SUNDRY NOTICES AND REPORTS ON WELLS

8. Well Name and No.
83

ROSA UNIT NO. 83.

Proposed Plug & Abandon Procedure

PROPOSED P & A SCHEMATIC

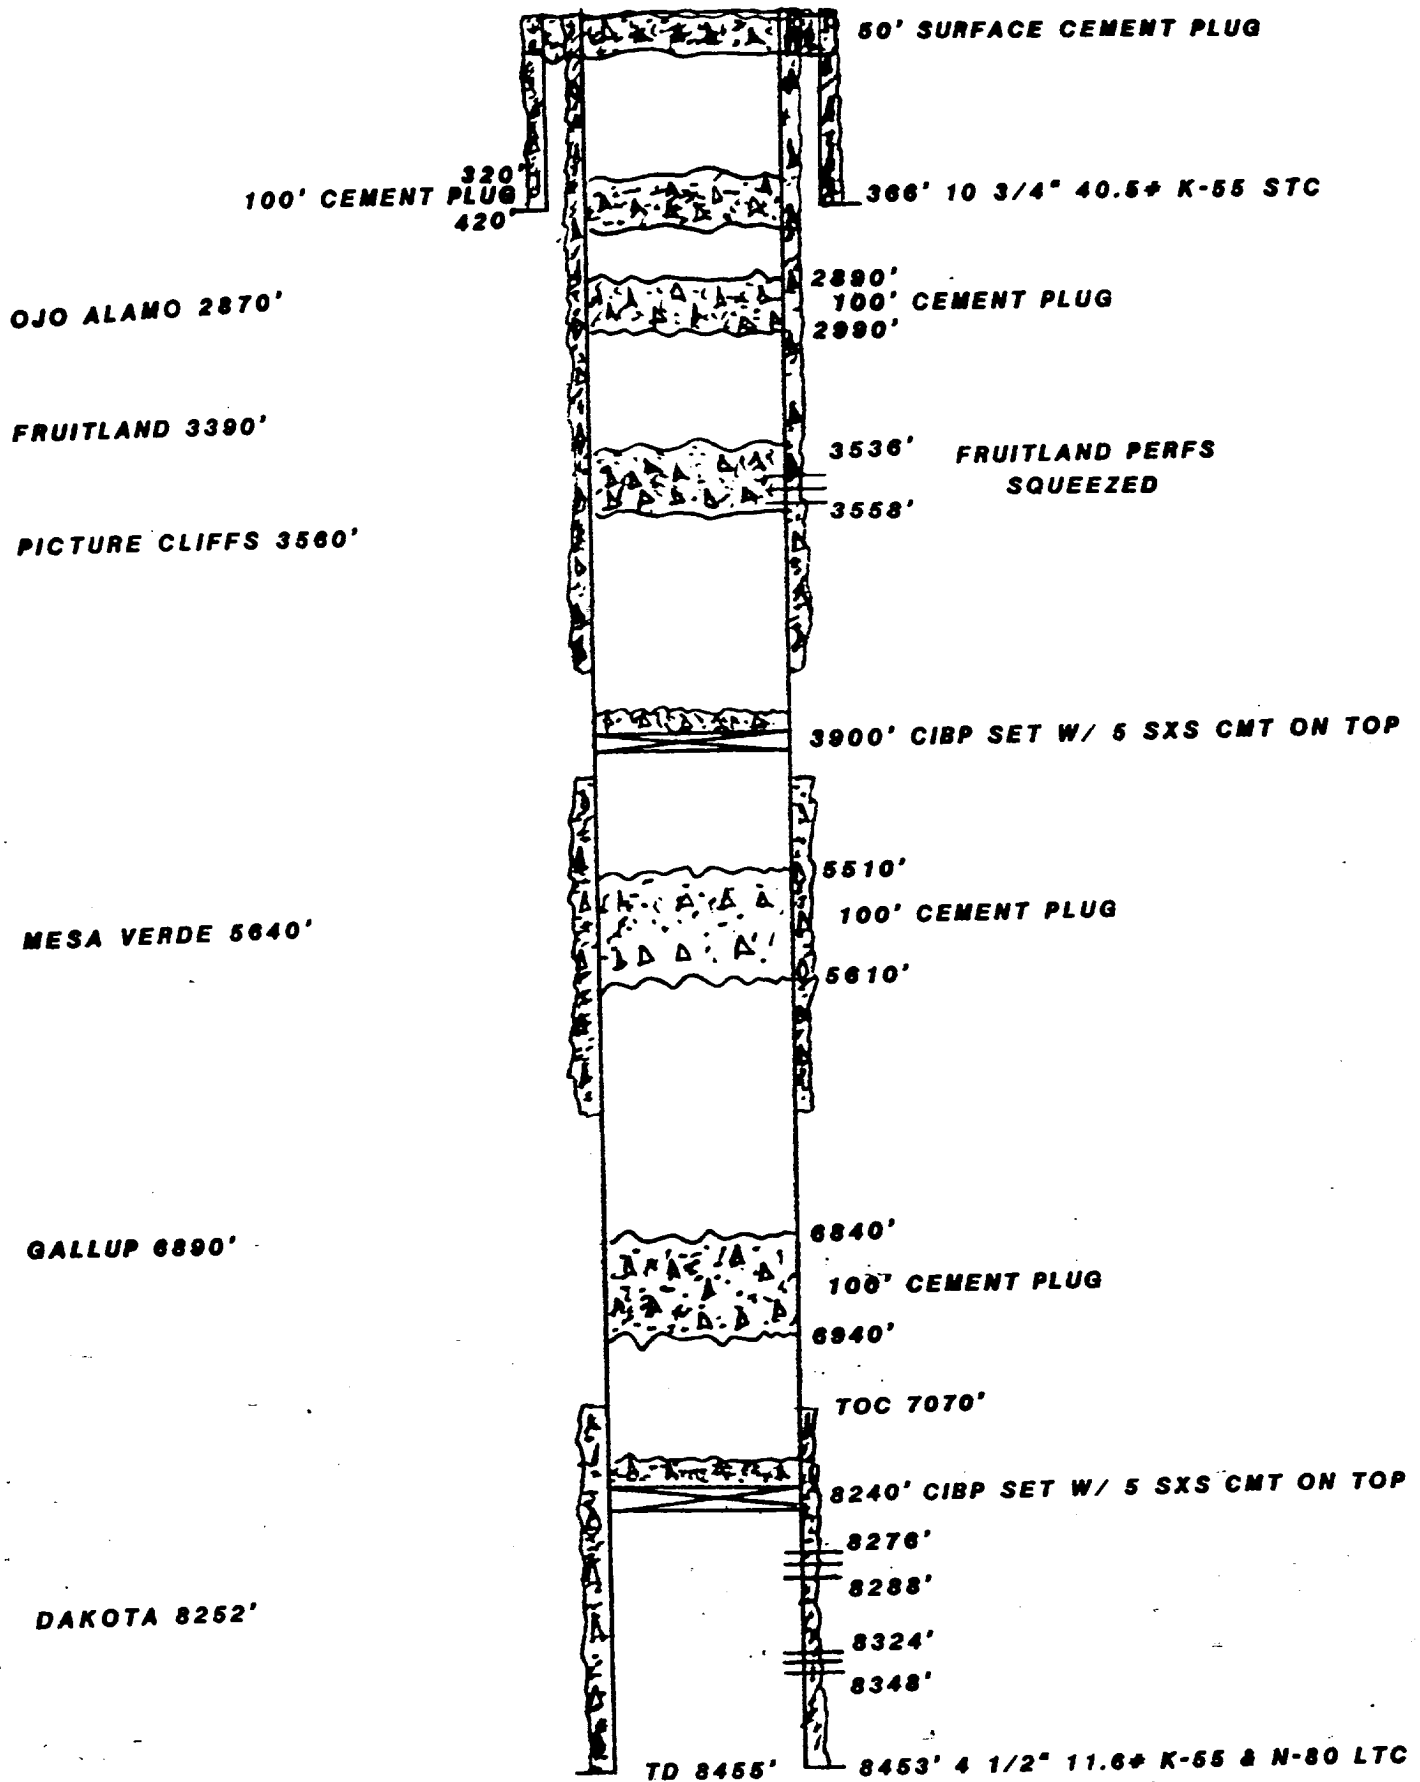
a) Bring Fractured Plug up to 3018'

b) You are required to place cement outside 4 1/2" casing across any ~~interval~~ interval where a plug is being placed inside the 4 1/2" casing.

PROPOSED SCHEMATIC

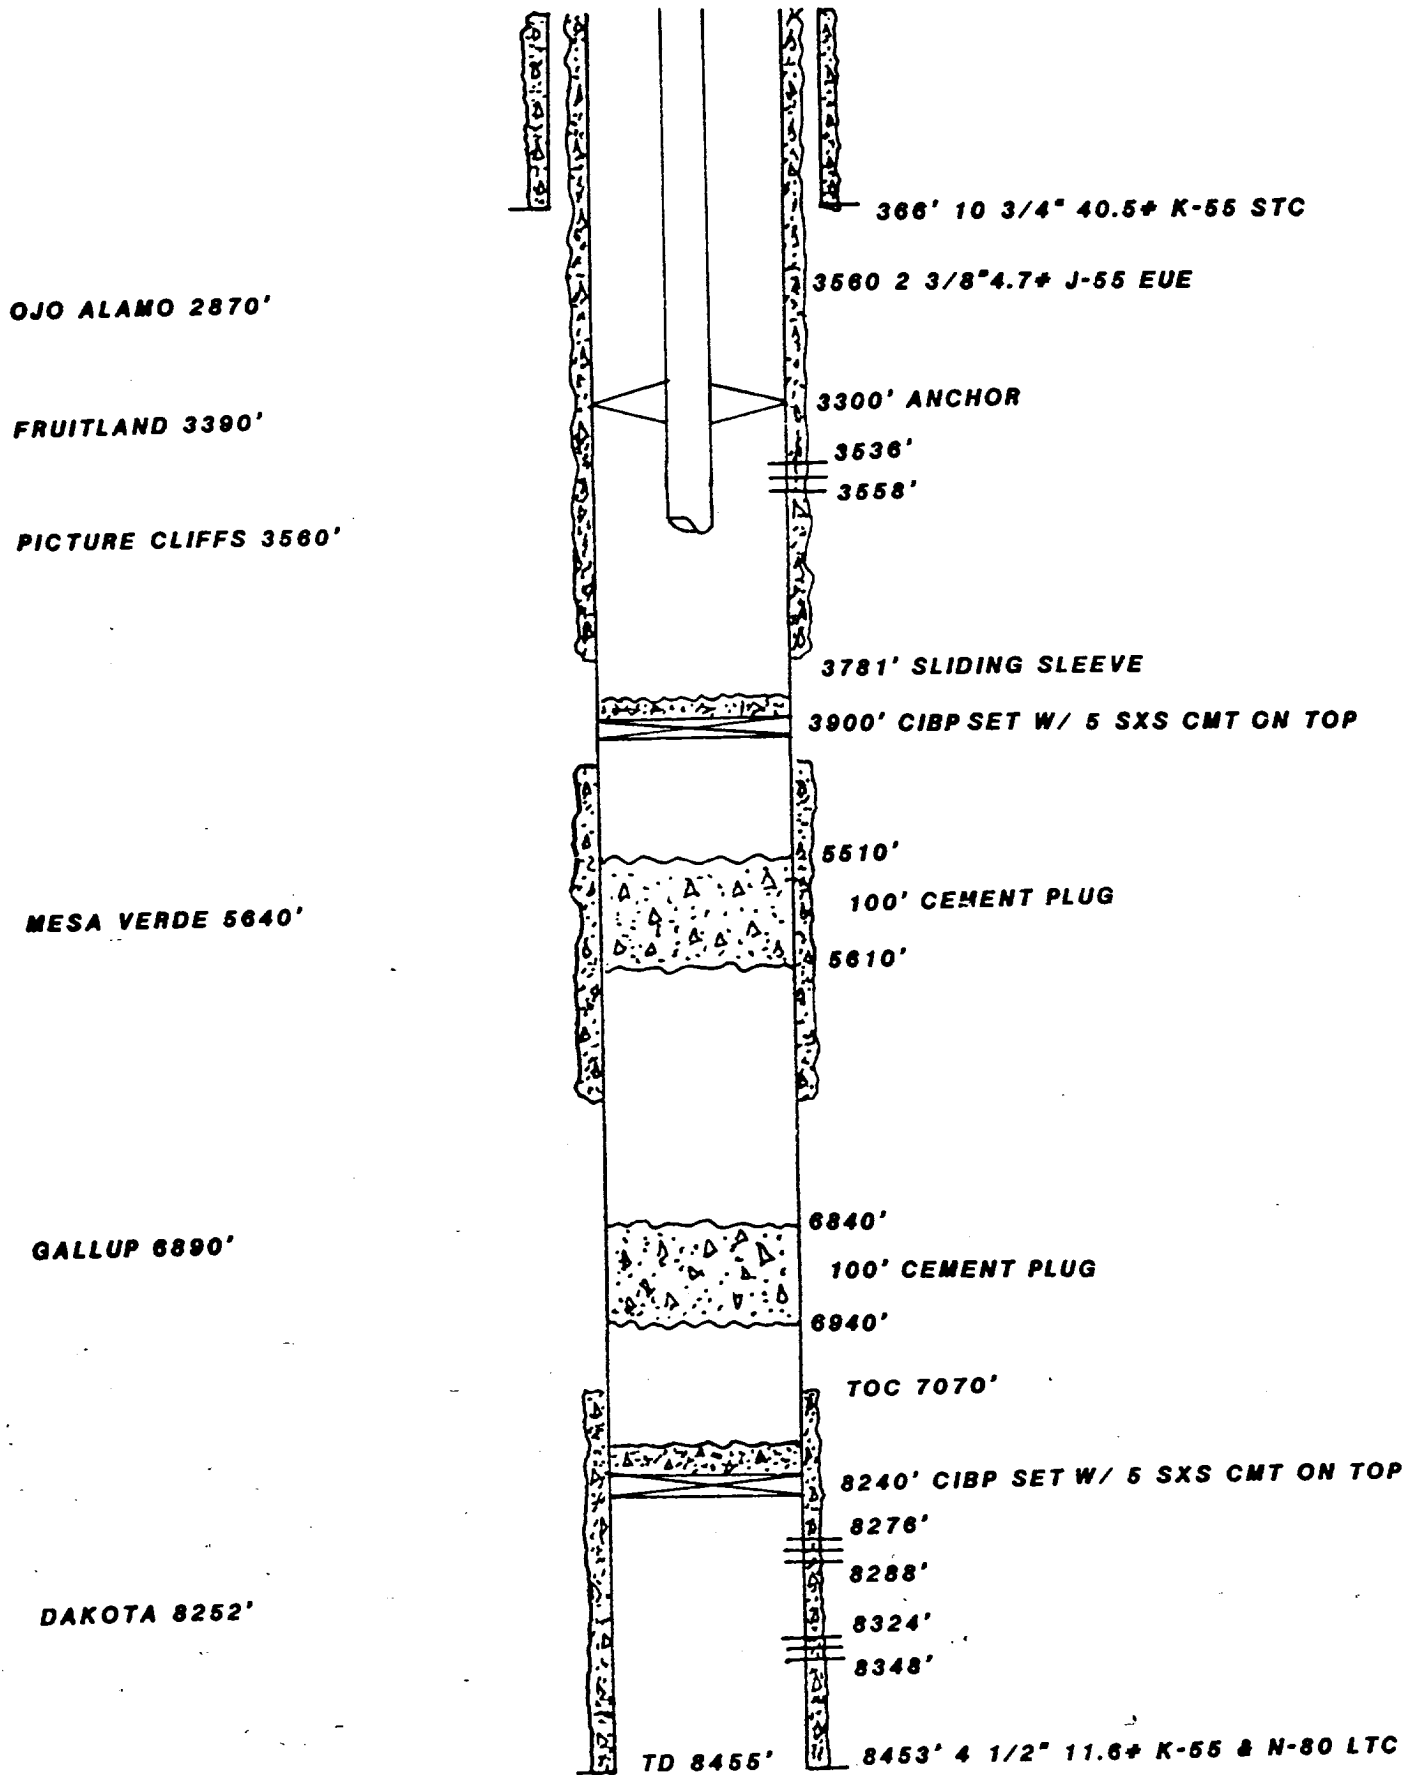
1. MI & RU pulling unit. ND wellhead & NU BOP's.
2. TIH w/tbg to $\pm 8200'$ & circ hole w/9.0#/gal mud.
3. Spot 100' cement plugs while POOH from 6840'-6940' (Gallup Formation) & ~~5590'-5690'~~ (Mesa Verde Formation). POOH.
5510 - 5610

4. TIH w/CIBP & set @ $\pm 3900'$ & dump 5 sxs cement on top.
5. TIH w/perforating gun & perf from 3650'-3652' w/4 SPF for squeeze.
6. TIH w/squeeze tool & attempt to circ from perfs @ 3652' to surface. If able to circ then cement 4-1/2" csg from 3658' to surface. If unable to circ squeeze perfs 3650'-3652' w/ ± 100 sxs cement. Also perf from $\pm 3510'$ -3512' & also squeeze w/100 sxs cement. POOH. *It is required that the annular interval from 2890' to 3120' be cemented. (Ojo Alamo 2940' to 3068')*

7. TIH w/CBL-GR Logging tool & log from PBTD ($\pm 3850'$) to surface.
8. TIH w/perf gun & perf Fruitland Formation from ~~3591'-3594'~~ *P.C.* & 3558'-3536'.
